Service Bulletin

PRELIMINARY INFORMATION

Subject: OnStar XM GPS or Antenna Malfunction - May Set DTC B2462 B2470 Or B125C - Water Leak In Headliner Or Overhead Console

Models: 2015 Cadillac Escalade Models
2015 Chevrolet Silverado, Suburban, Tahoe
2015 GMC Sierra, Yukon Models
Equipped with High Frequency Painted Antenna Assembly
Built Before:
3/24/15 if 11th vin digit = "F"
3/2/15 if 11th vin digit = "G"
2/26/15 if 11th vin digit = "R"

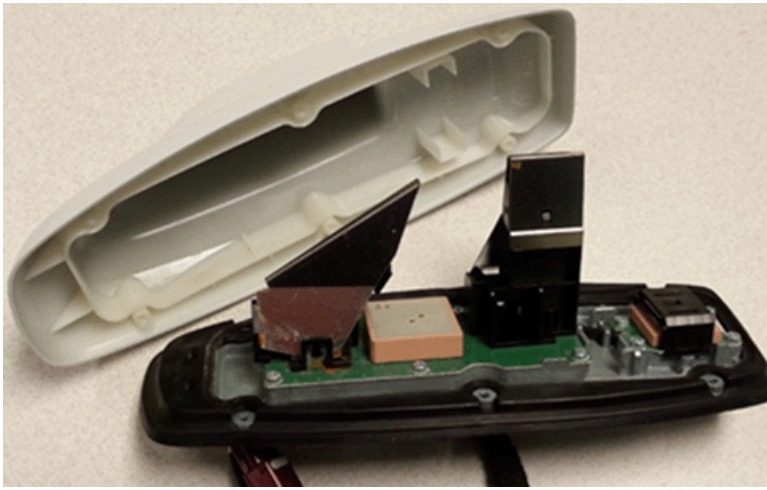
Note: This recommendation only applies to vehicles equipped with the high frequency "painted" antenna assembly after built before the dates listed. Engineering has identified an issue of water intrusion into the body of the antenna assembly which can ultimately travel down the wiring pigtail into the vehicle. There have also been cases of water leaks from underneath the antenna at the roof panel opening. Inspect the roof sheet metal to ensure there is no deformation at or near the antenna pass-thru opening

If the antenna performance concerns outlined and/or one of the water leak concerns are encountered, replace the antenna ensuring to use the latest antenna part number available from CCA parts without removing the cover from the base.

Important: The painted antenna cover is NOT intended to be removed. Do Not remove the antenna cover from the antenna base, as this may compromise the sealing performance of the new part.
